# VILLAGE OF BARRINGTON HILLS

## Plan Commission

NOTICE OF MEETING

Communication: Application and Site Plan (Barrington Hills Farm - Equestrian Facility)

**Barrington Hills Farm**
**McHenry County, Illinois**
**Preliminary Site Plan**

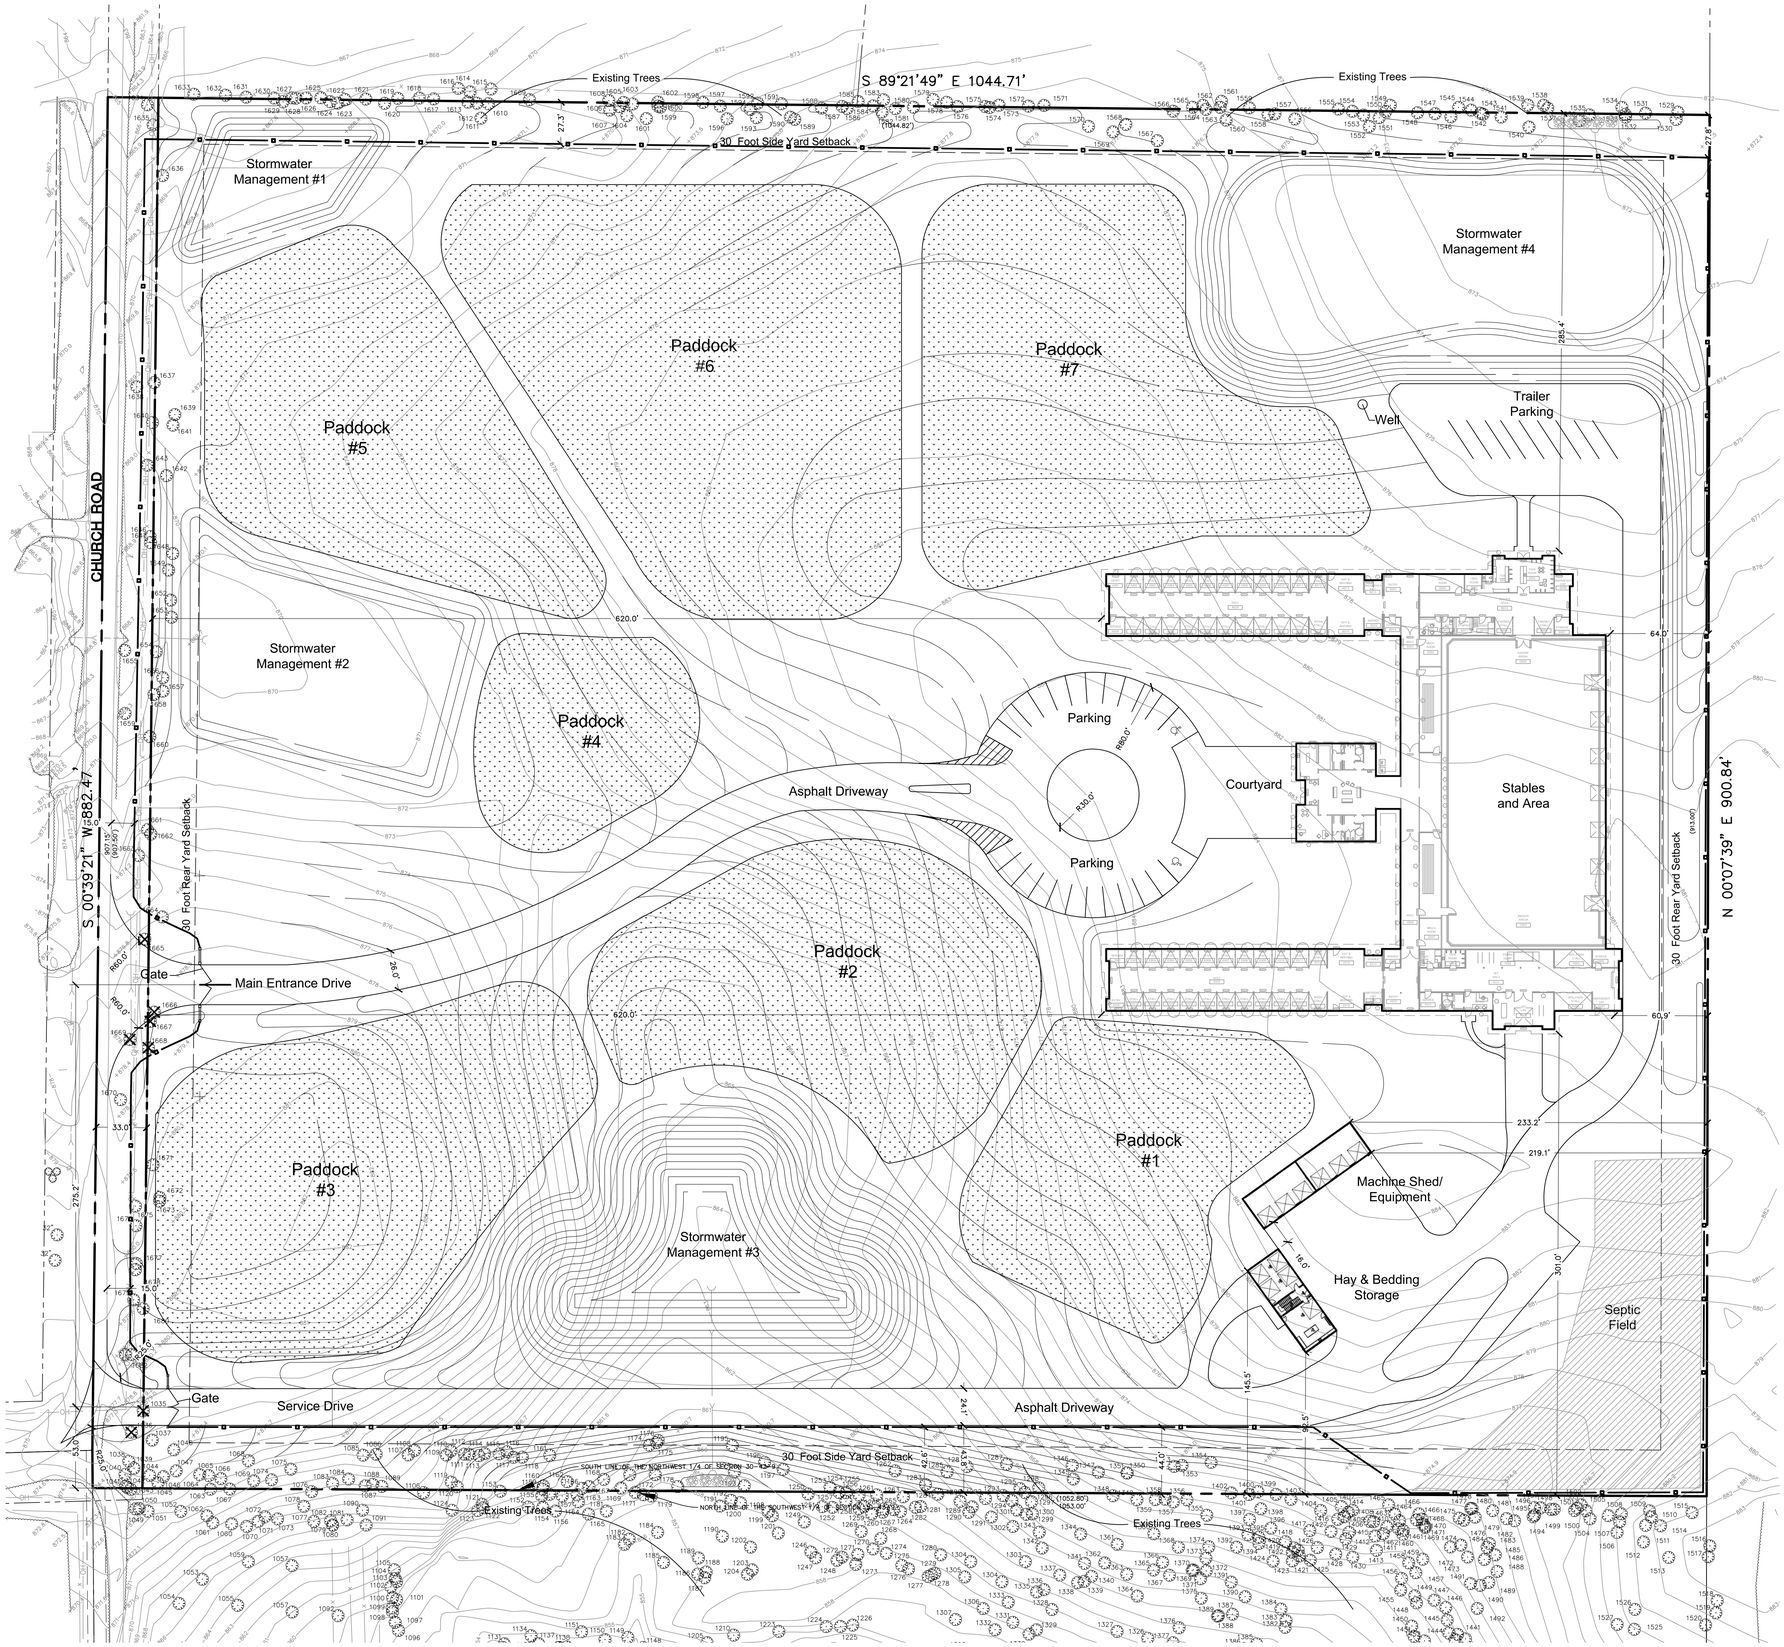
- ☑ There are parking space minimums for offices and animal care shelters. A rough estimate of those portions of the building came to 19 spaces. The site plan provides for 24 spaces, including 2 handicap spaces. There are no specific parking requirements for horse stables. (Table 16-1)
- ☑ Aisle width and stall depth sufficient for head-in parking. (Figure 16-1)
- ◇? Stall width not able to be calculated. Minimum 9 feet. (Figure 16-1)
